STAFF REPORT & DECISION

CITY OF LA CENTER

GORDON CREST POST DECISION REVIEW
2012-019-PDR

-
- Proposal:** The applicant requests a post-decision review to: alter previously approved lot dimensions, and; to reduce the total number of approved lots.
- Location:** The site is located in the southwest quarter of Section 34, Township 5 North, Range 1 East of the Willamette Meridian and includes Clark County Assessor Tax Lots 258894-048 (lot 24); 258894-050 (lot 25); 258894-052 (lot 26); 258894-054 (lot 27); 258894058 (lot 29); 258894060 (lot 30); 258894062 (lot 31); 258894064 (lot 32); 258894066 (lot 33); 258894068 (lot 34) and; 258894128 (Tract D/new lot 61).

EXHIBIT SKETCH of
 BOUNDARY ADJUSTING LOT 24 & LOT 26
 (ELIMINATING LOT 25)
 of GORDON CREST

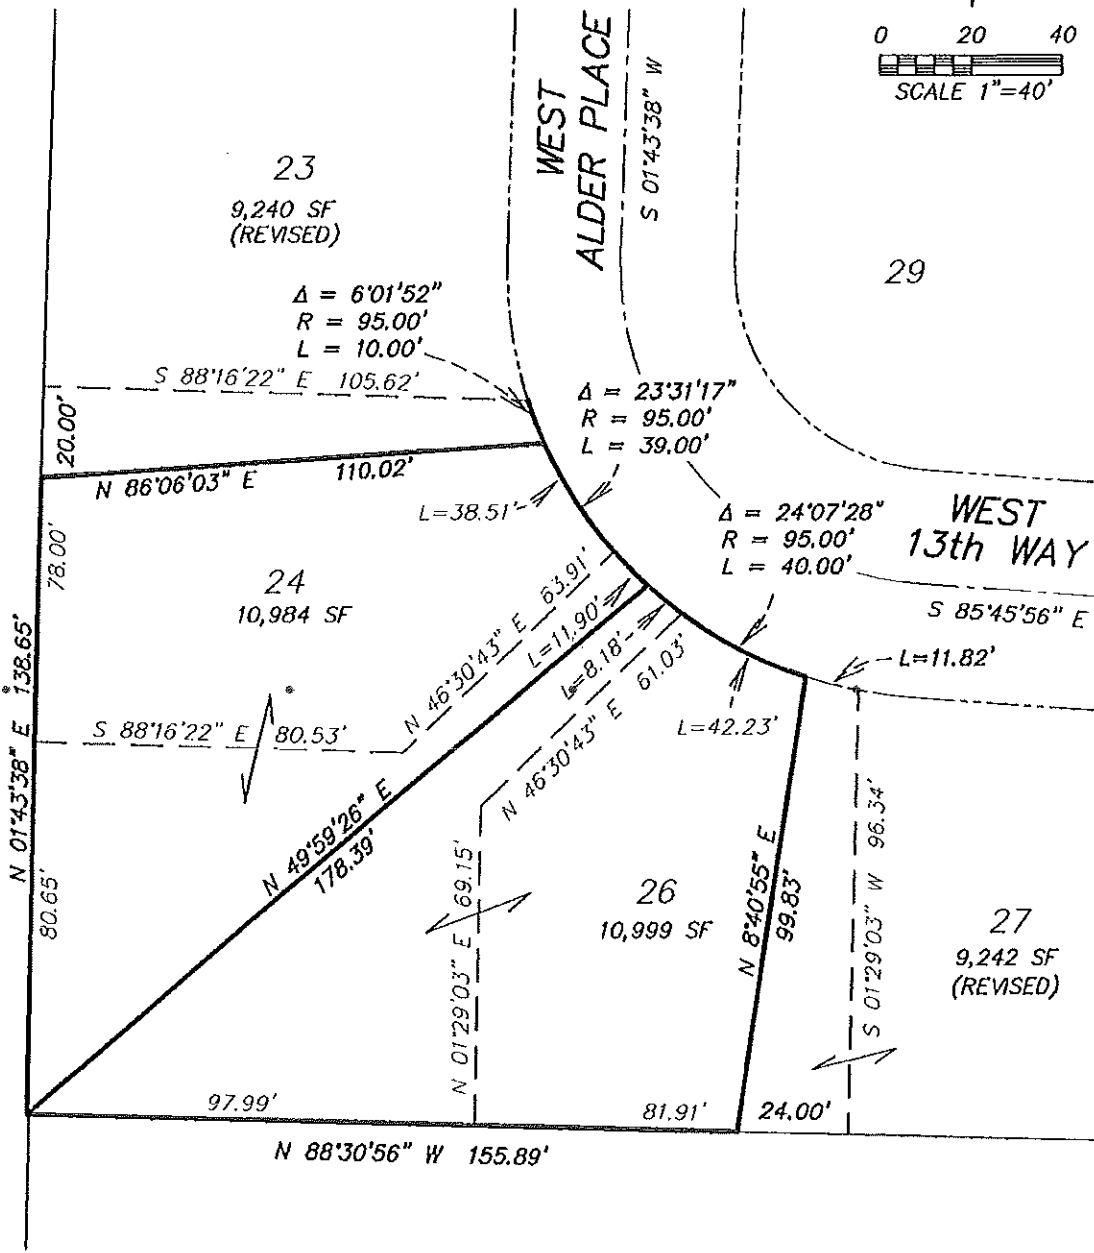
The applicant proposes to alter the area of ten (10) lots and remove two (2) lots entirely.

Finding(s): The proposed revision reduces the number of approved lots. All resulting lots meet applicable density requirements of LCMC 18.130.080. See Table 1.

EXHIBIT SKETCH of
 NEWLY CREATED LOT 61
 (FORMERLY TRACT D)
 and BOUNDARY ADJUSTED
 LOTS 29 & 61
 of GORDON CREST

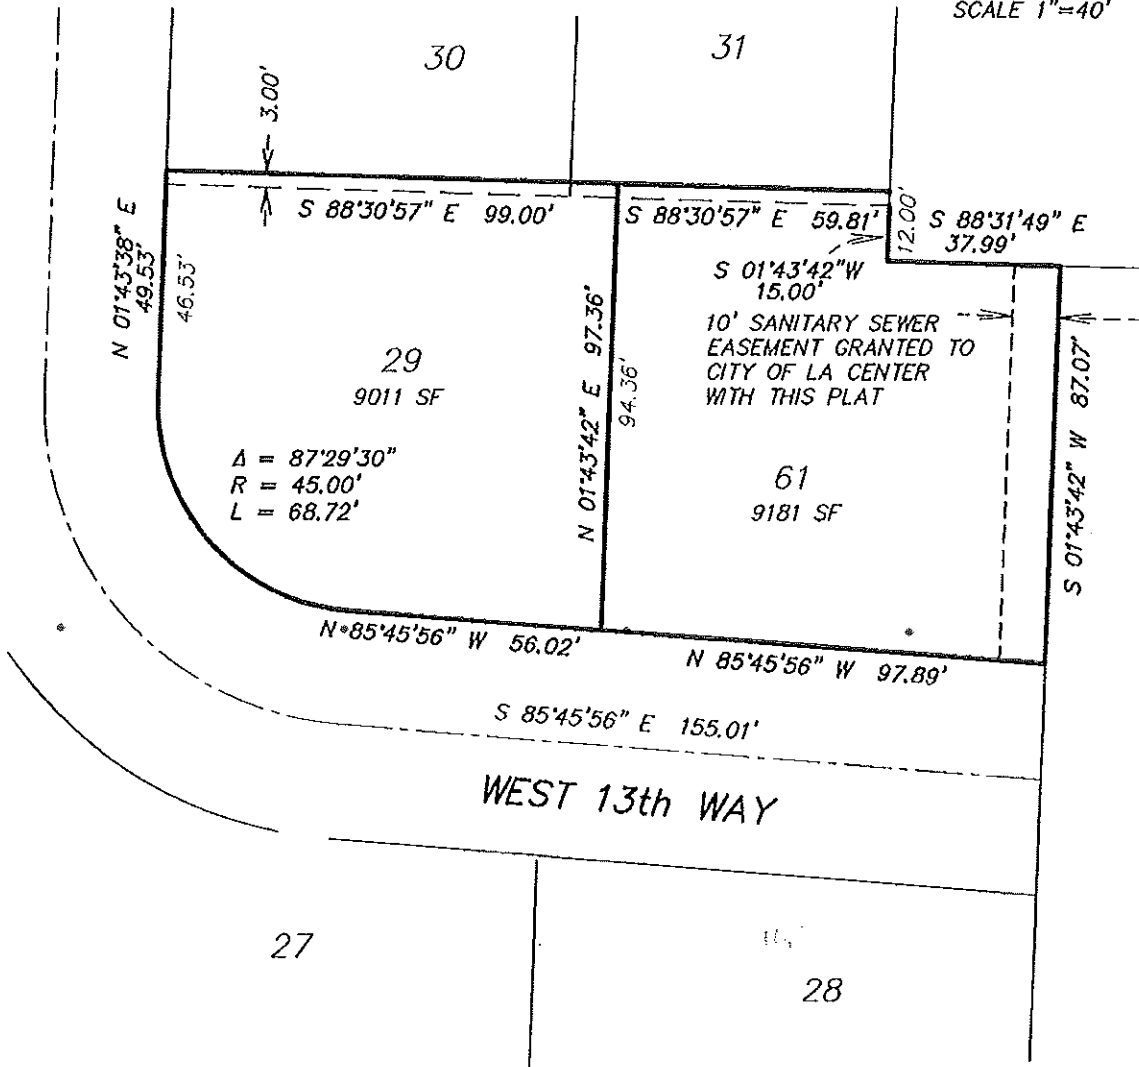
Finding(s): The applicant proposes to change Tract D into Lot 61. Original Condition of Approval #18 states, "The turnaround for 13th Street shall be temporary and provided for with an easement on the lot or tract (Tract D)." The need for this turnaround is satisfied by the extension of West 13th Street east to Aspen Avenue¹. West 13th Street has been constructed east to Aspen Avenue as part of Gordon Crest II subdivision (2006-012-SUB). However, this subdivision has not yet received final plat approval and is not to be construed as final approval of the Gordon Crest II subdivision plat.

Condition(s): Lot 61 is approved contingence to the City's acceptance of West 13th Street.

1. Lot 61 is approved contingent upon the City's acceptance of West 13th Street.
